Subject: Submittal of the Phase II Investigation Work Plan for Threemile Canyon Aggregate Area, Revision 3

Phase II Investigation Work Plan for Threemile Canyon Aggregate Area, Revision 3

**Response to Draft New Mexico Environment Department Comments on the
Phase II Investigation Work Plan for Threemile Canyon Aggregate Area, Revision 2,
Dated April 29, 2021**

Figure 4.5-1 Site map and proposed sampling locations at SWMU 15-010(b)

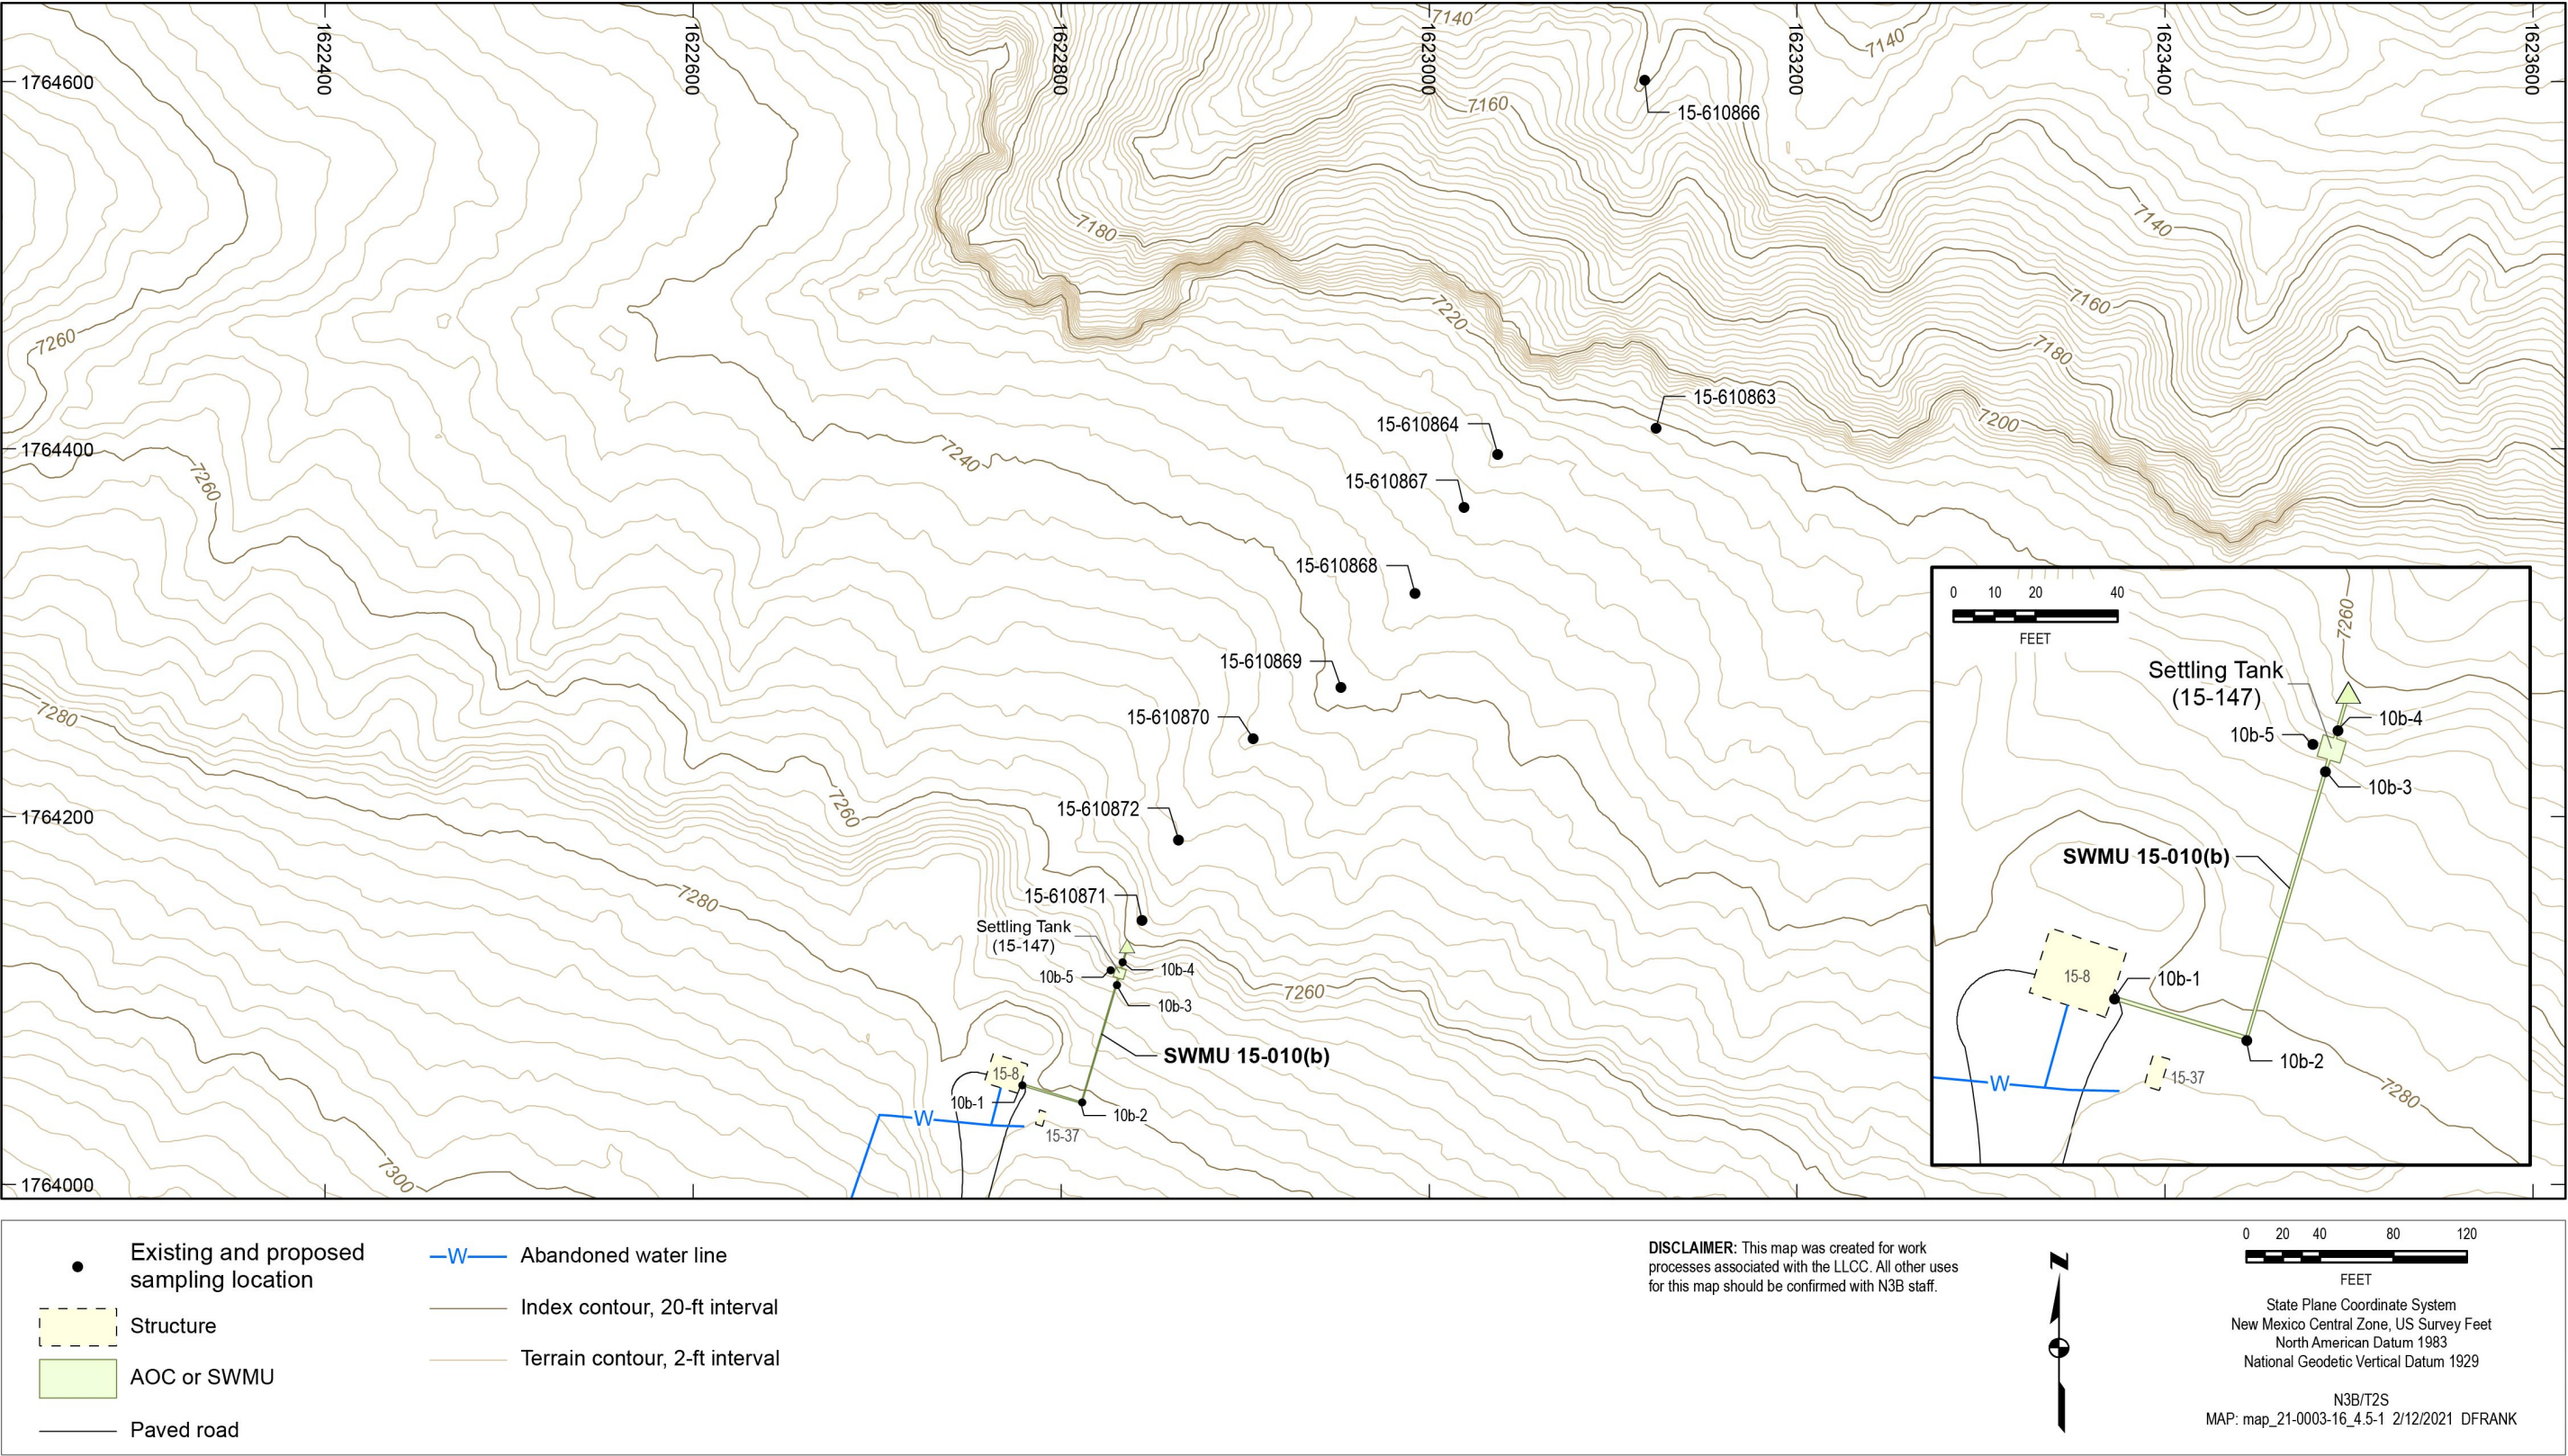
The proposed sampling locations specify that: "A borehole will be advanced as close as possible to the middle of the tank sidewall (location 10b-5 in Figure 4.5-1)." This sampling location will only address the area adjacent to middle of tank sidewall on one side. The proposed activities clarify that the settling tank will be inspected for liquids and emptied if any liquid or sludge remains in the tank. It is then stated that: "After the tank has been emptied, it will be inspected for visual evidence of cracks, and the depth to the bottom of the tank, tank inlet, and take outlet will be measured." However, the proposed activities do not include additional sampling locations needed if the tank is inspected and determined to have cracks. Sampling only adjacent to the middle of the tank sidewall will not address the potential seepage of contamination from any cracks that may be discovered. If cracks in the settling tank are present at the time of the inspection as described in Section 4.5.3, additional samples must be collected at varying depths below the tank to determine if contaminant seepage occurred and to define the extent of vertical and lateral potential contamination.

3. As stated in section 4.5.3, the settling tank will be inspected for visual evidence of cracks. If cracks are noted during the visual inspection, additional samples will be collected at varying depths below the tank to determine if contaminant seepage occurred. The text in section 4.5.3 will be revised to include the following sentence: "If cracks are observed during visual inspection, a borehole will be advanced on both sides of the tank, as close as possible to the sidewall and adjacent to the crack location."
